APPLICATION FOR PERMISSION UNDER SECTION 16 OF THE TOWN PLANNING ORDINANCE (CAP.131)

For Official Use Only 請勿填寫此欄	Application No. 申請編號	A/YL-KTS/974
	Date Received 收到日期	- 4 AUG 2023

Proposed Temporary Shop and Services for a Period of 5 Years

Application No. 申請編號	(For Official Use Only) (請勿填寫此欄)		
Location/address 位置/地址	Lot 291 (Part) in D.D. 109, Kam Sheung Road, Kam Tin, Yuen Long, N.T.		
Site area 地盤面積	3,400 sq. m 平方米 <input checked="" type="checkbox"/> About 約 (includes Government land of 包括政府土地 Nil sq. m 平方米 <input type="checkbox"/> About 約)		
Plan 圖則	Approved Kam Tin South Outline Zoning Plan No. S/YL-KTS/15		
Zoning 地帶	'Village Type Development' ("V")		
Applied use/ development 申請用途/發展	Proposed Temporary Shop and Services for a Period of 5 Years

Proposed Drainage Plan

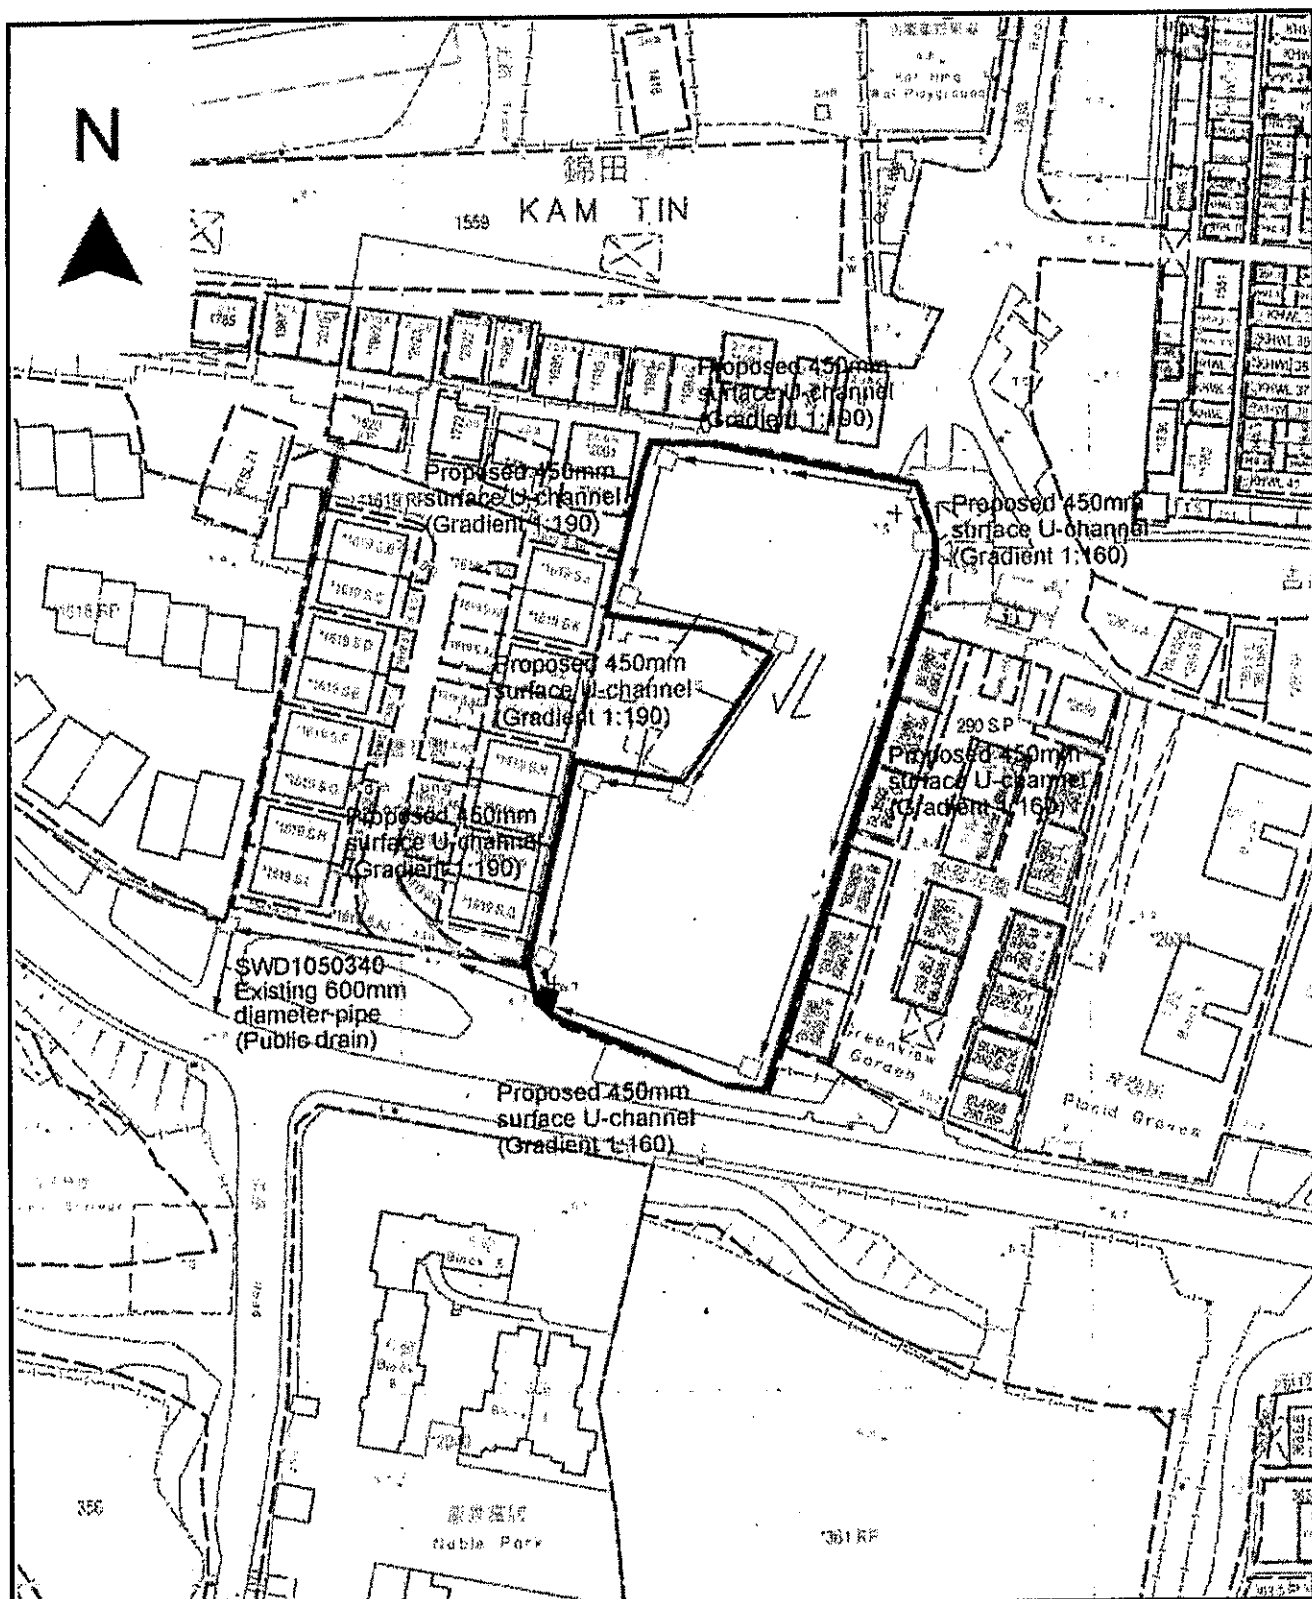
- 2.3.1 Subject to the above calculations, it is determined that 450mm surface U-channel along the inner site periphery is adequate to intercept storm water passing through and generate at the subject site (**Figure 4**).

- 2.3.2 The intercepted stormwater will be discharged to the existing public drain to the west of the subject site. (**Figure 4**)
- 2.3.3 All the proposed drainage facilities will be provided and maintained at the applicant's own expense.

Proposed Fire Services Installation Plan

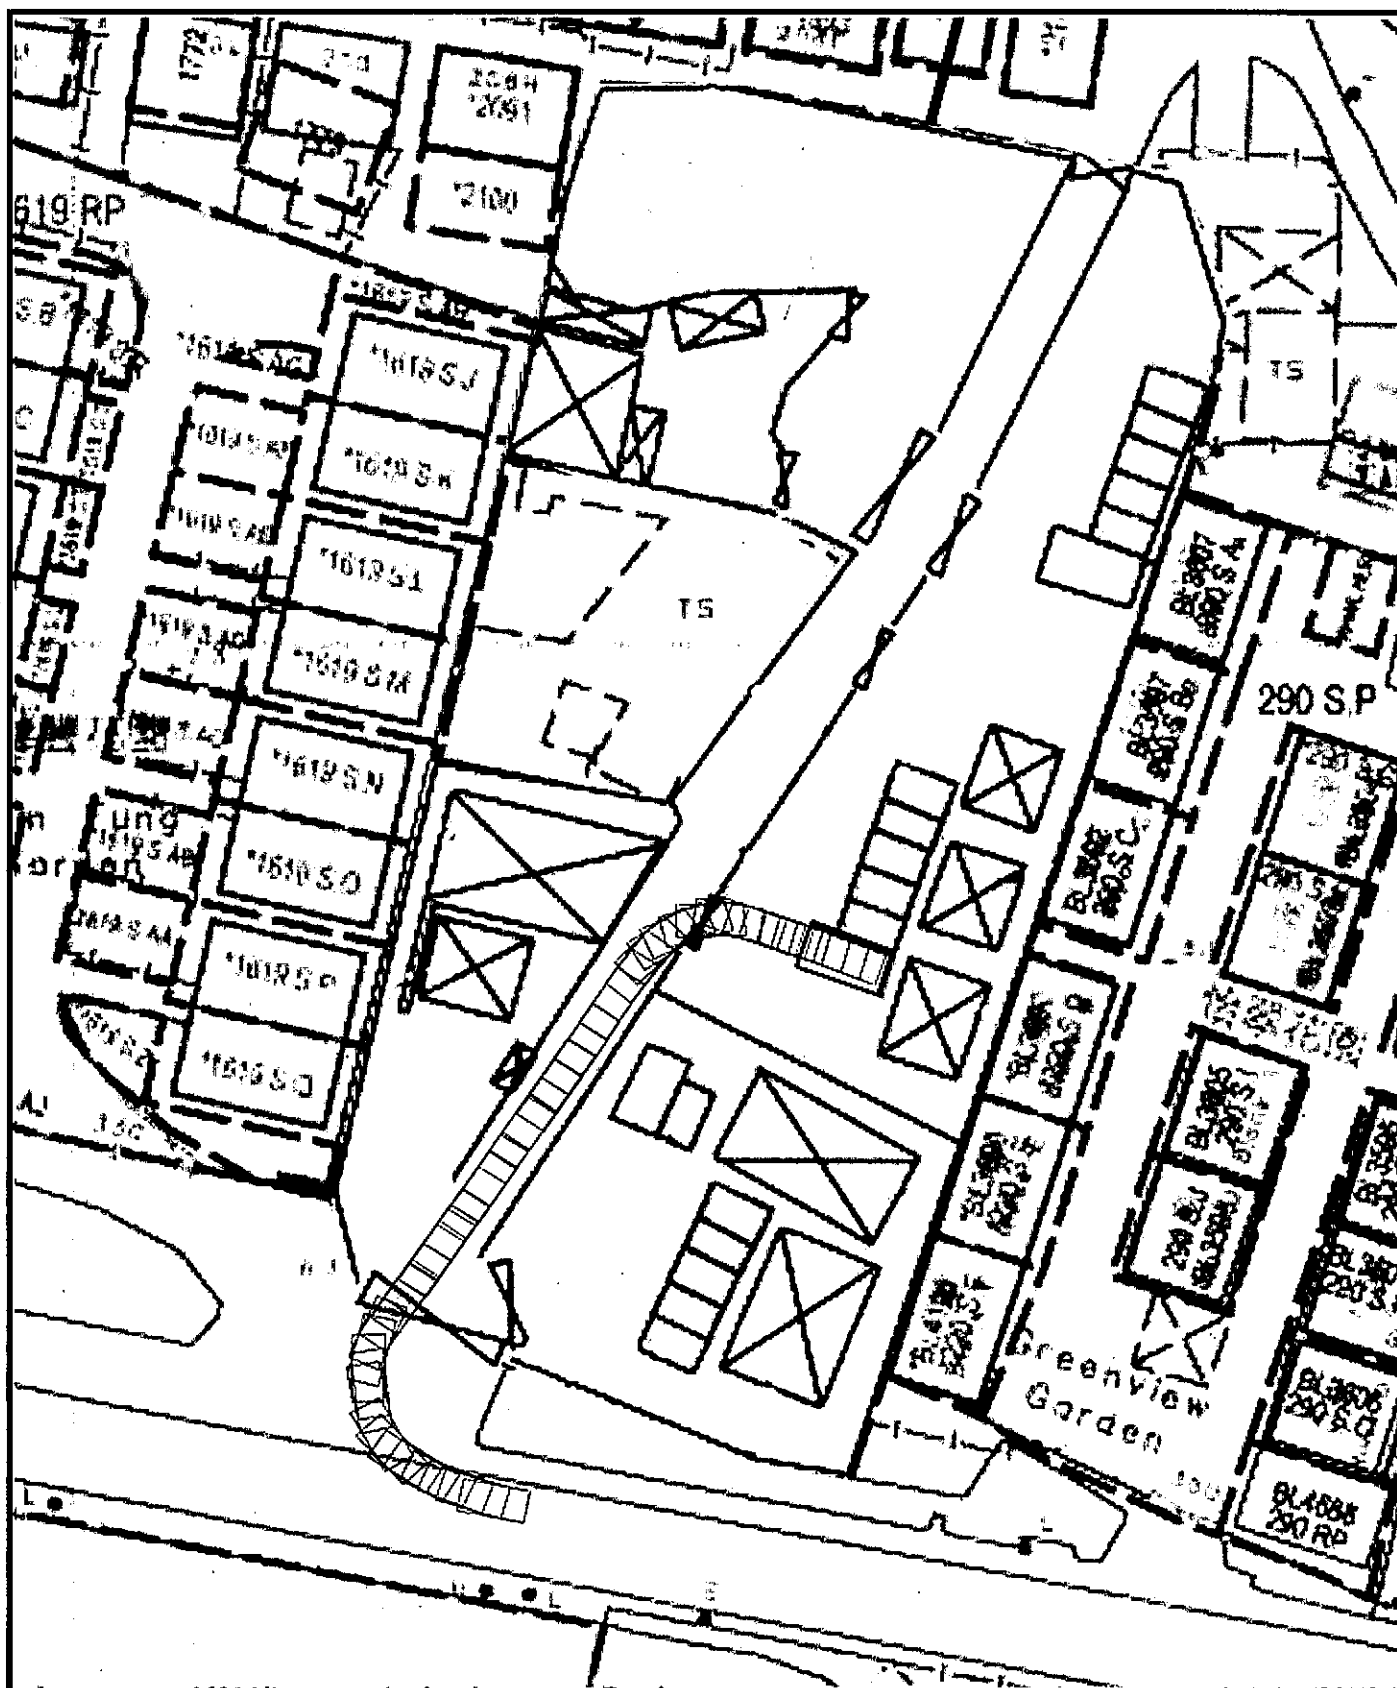
Fire Services Department's comments	Applicant's response
In consideration of the design nature of	Noted. Please see the FSI plan in the

<p>the proposal, FSIs are anticipated to be required. Therefore, the applicant is advised to submit relevant layout plans incorporated with the proposed FSIs to this Department for approval. In addition, the applicant should also be advised on the following points:</p> <ul style="list-style-type: none"> i. The layout plans should be drawn to scale and depicted with dimensions and nature of occupancy. ii. The location of proposed FSIs to be installed be clearly marked on the layout plan. 	<p>attachment.</p>
---	--------------------

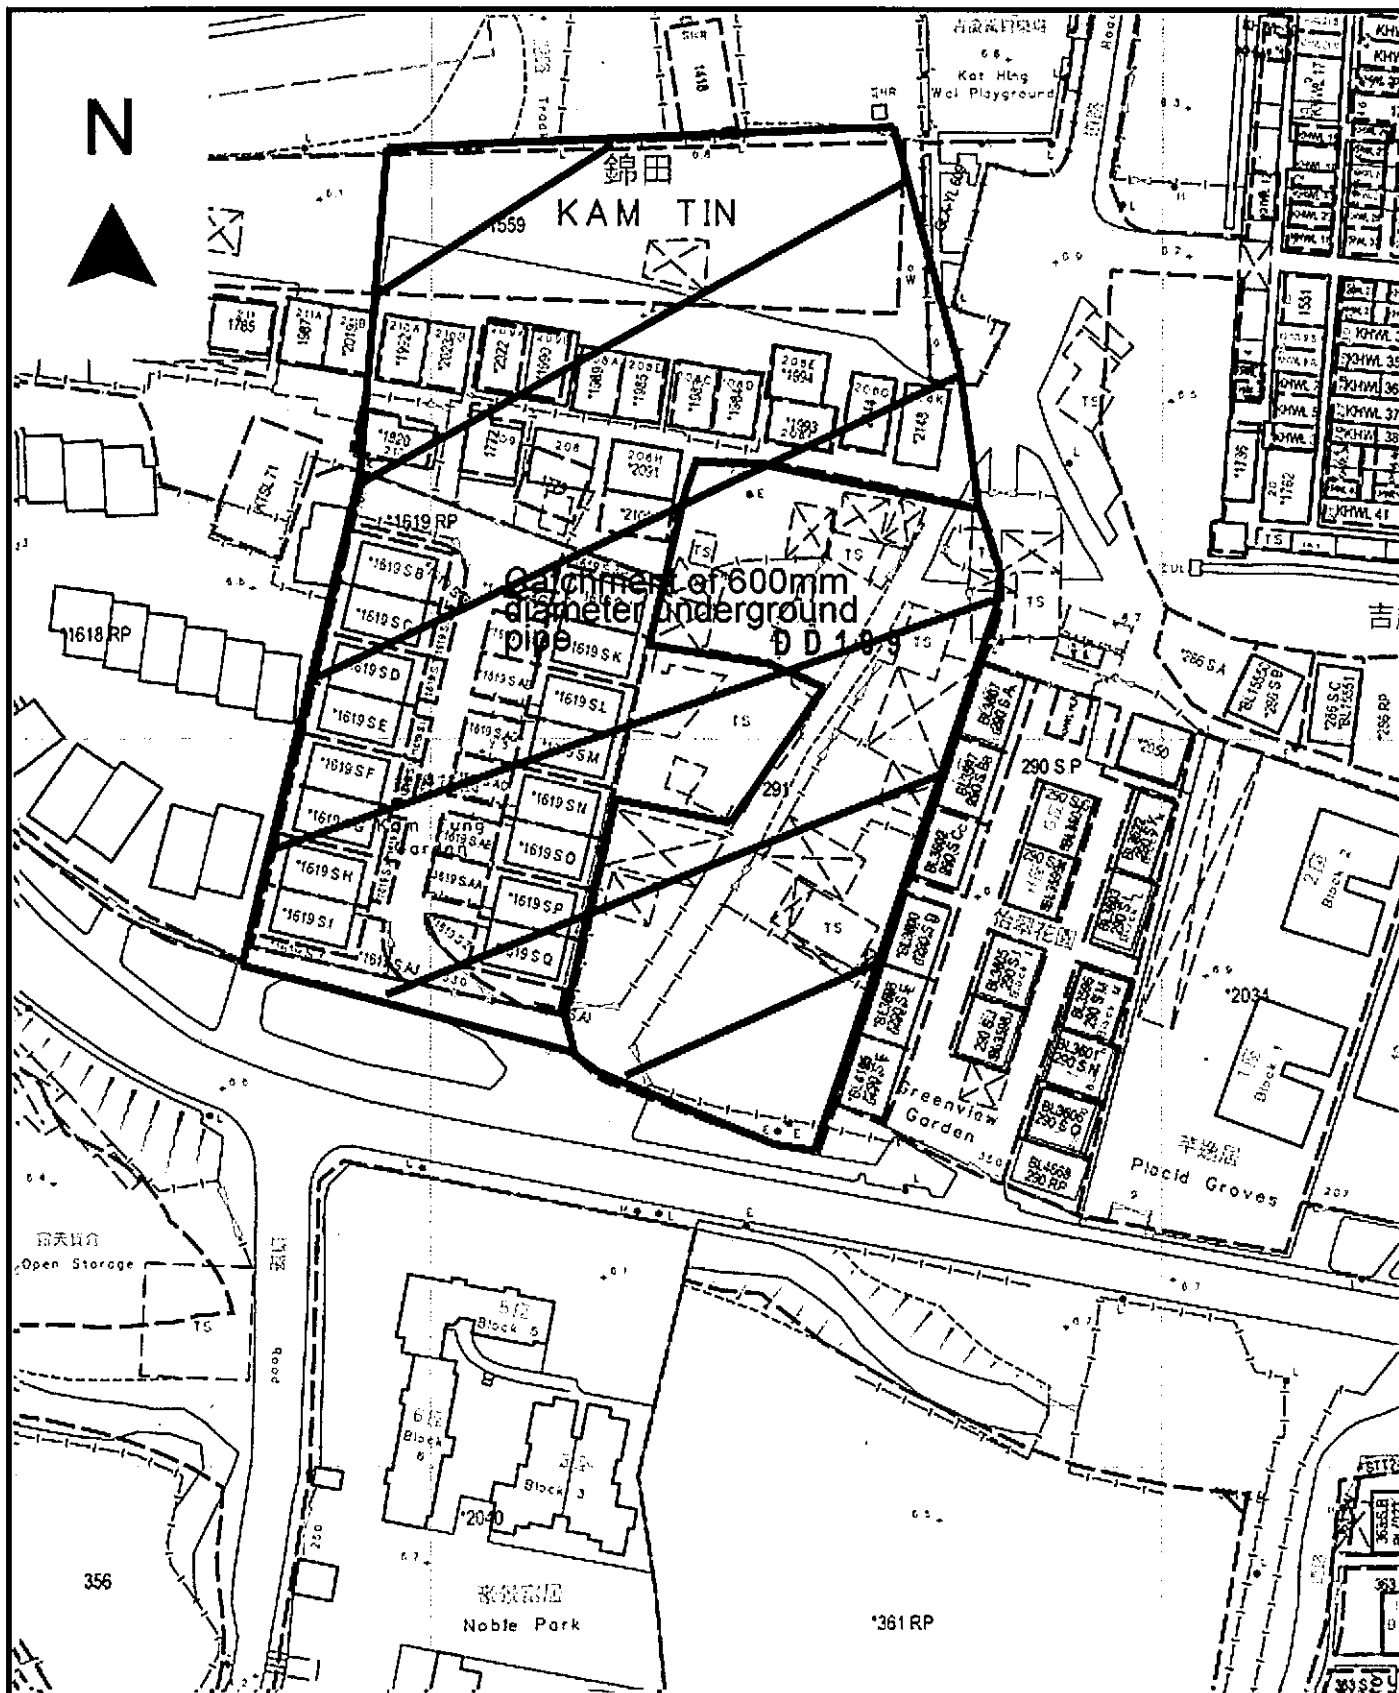
CE/MN, DSD's comments	Applicant's response
(i) Cross sections showing the existing and proposed ground levels of the captioned site with respect to the adjacent areas should be given.	Noted and please see updated drainage plan. No site formation will be carried out.
(ii) Please indicate the size and gradient of the proposed drain from the terminal manhole of the application site to another terminal manhole no. SLH1002640 for another lot(s) on the drainage plan. Please note that the above terminal manhole no. SLH1002640 is not maintained by DSD. Please seek comments from the relevant owners and consult DLO/YL for any drainage works to be carried out outside his lot boundary and the proposed connection works before commencement of the drainage works.	Noted.
(iii) The cover levels and invert levels of the proposed U-channels, catchpits/sand traps should be shown on the drainage plan.	Noted. Please see updated drainage plan.

(iv) Please provide a drawing showing the details of the proposed opening of the hoarding to intercept the existing	Site hoarding would be provided along the site periphery. 100mm opening would be provided at the toe of the site

overland flow passing through the site for comments.	hoarding to allow the uninterrupted flow of stormwater. Please see updated drainage plan.
(v) The development should neither obstruct overland flow nor adversely affect existing natural streams, village drains, ditches and the adjacent areas, etc.	Noted.

Proposed Fire Services Installation Plan

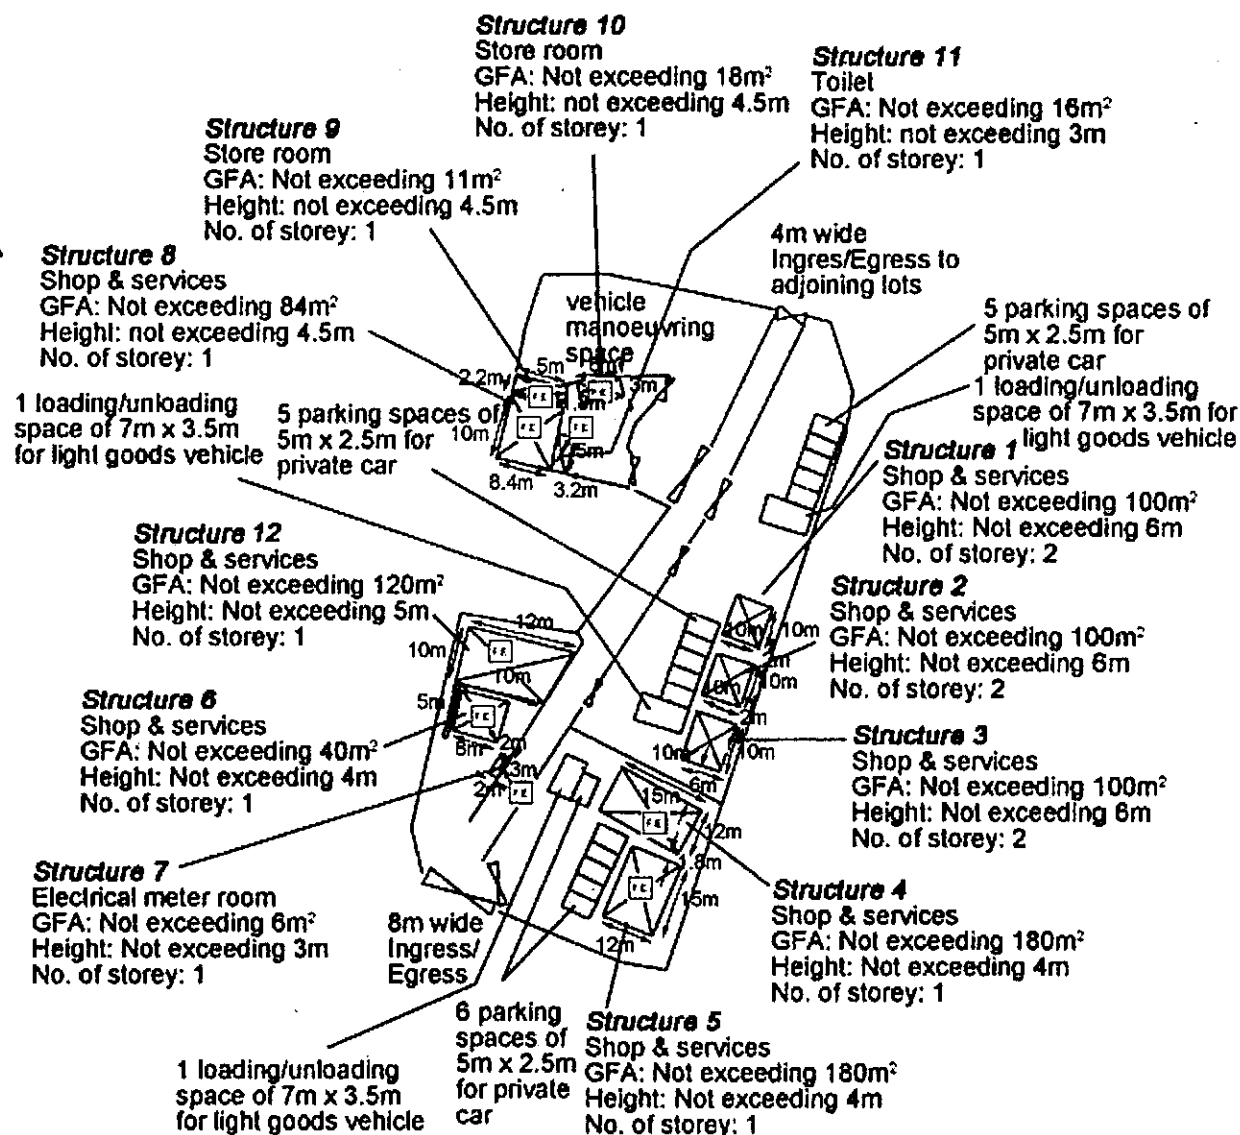
Fire Services Department's comments	Applicant's response
i. Layout plans of every structures 1, 2 and 3 shall be provided.	Noted. Please refer to the updated FSI plan.
ii. Fire extinguishers shall be provided in every storey of Structures 1, 2 and 3.	Noted. Please refer to the updated FSI plan.
iii. The separation distance between each structure shall be clearly indicated on the plan; and	Noted. Please refer to the updated FSI plan.
iv. In relation to the above, structures on the same site are regarded as adjoining structures if they are less than 1.8m apart. Additional FSIs (i.e. sprinkler system, modified hose reel system, fire alarm system, emergency lighting and exit signs) shall be provided if the total floor area exceeds 230m ² .	Noted. Please note that structure 8 and 11 are adjoining structures but the total GFA for structure 8 and 11 is 100m ² only. Also, please note that structure 6 and 12 are adjoining structures but the total GFA for structure 6 and 12 is 160m ² only. As such, provision of fire extinguisher would be adequate for all the structures at the application site.

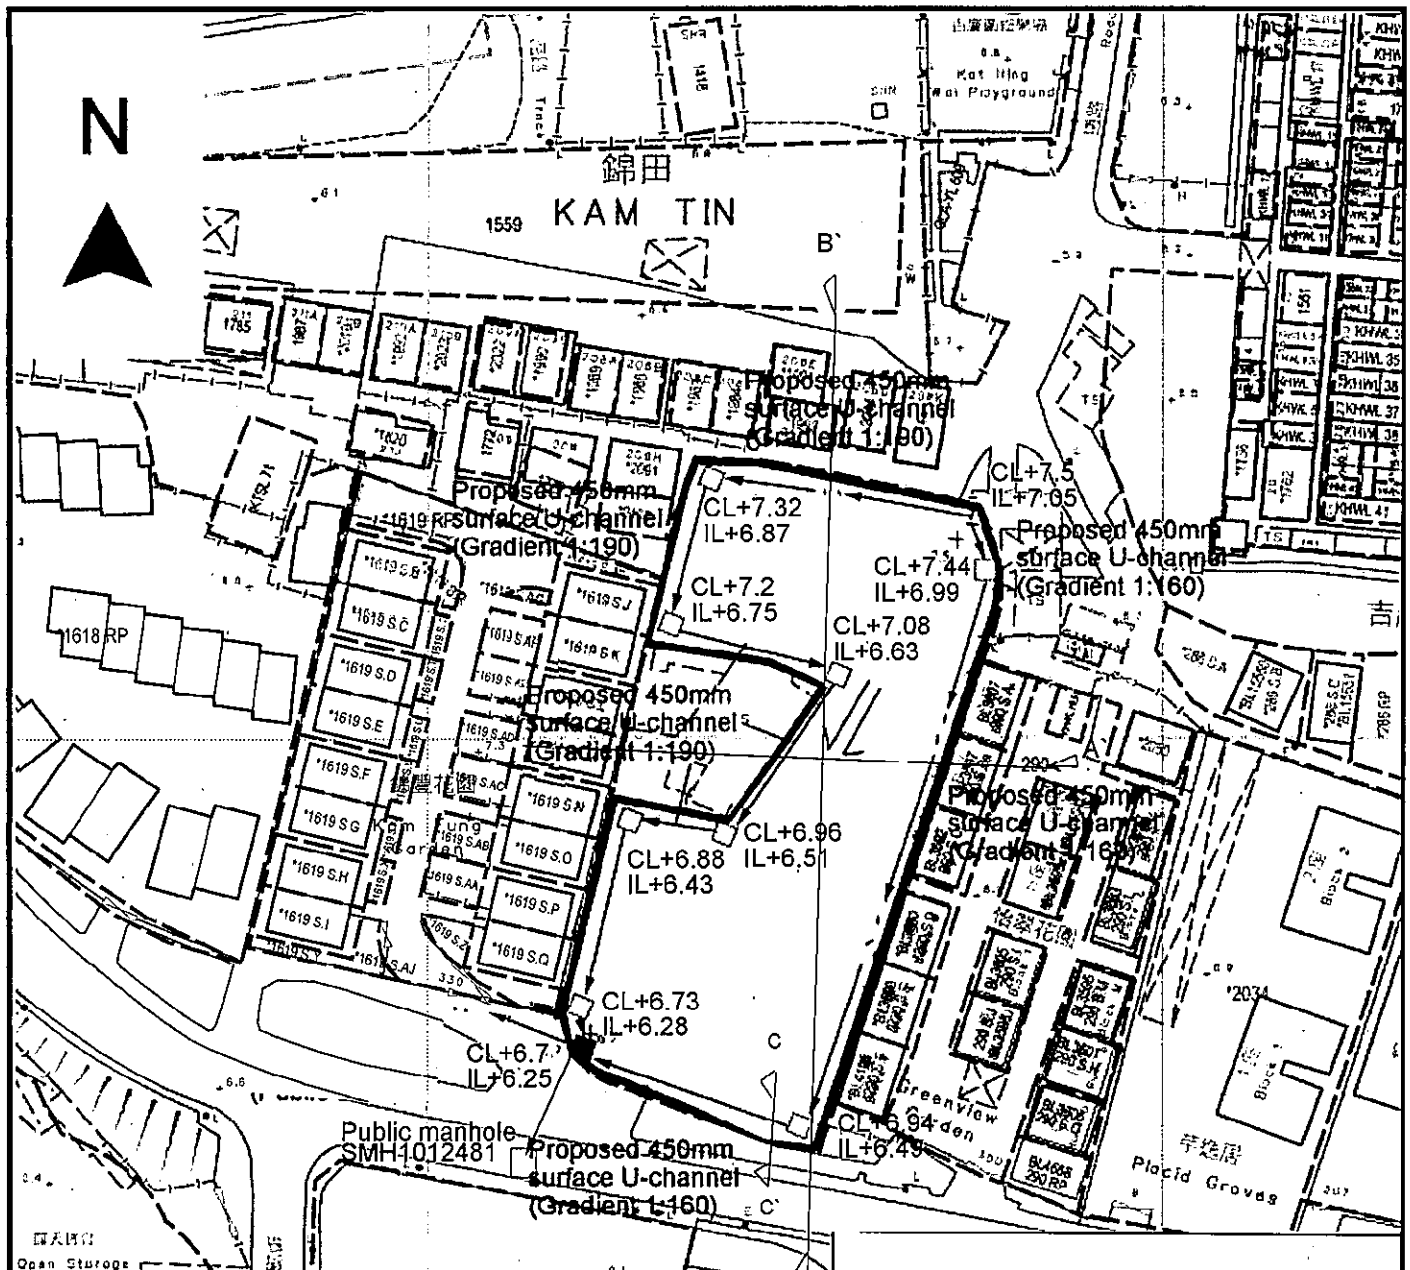
CE/MN, DSD's comments	Applicant's response
(i) The terminal SLH1012640 is not managed by this department. Consent from the owner of manhole SLH1012640 should be sought for the connection. The applicant may consider to make connection to government system.	Noted. The applicant will connect to the nearest manhole SMH1012481.
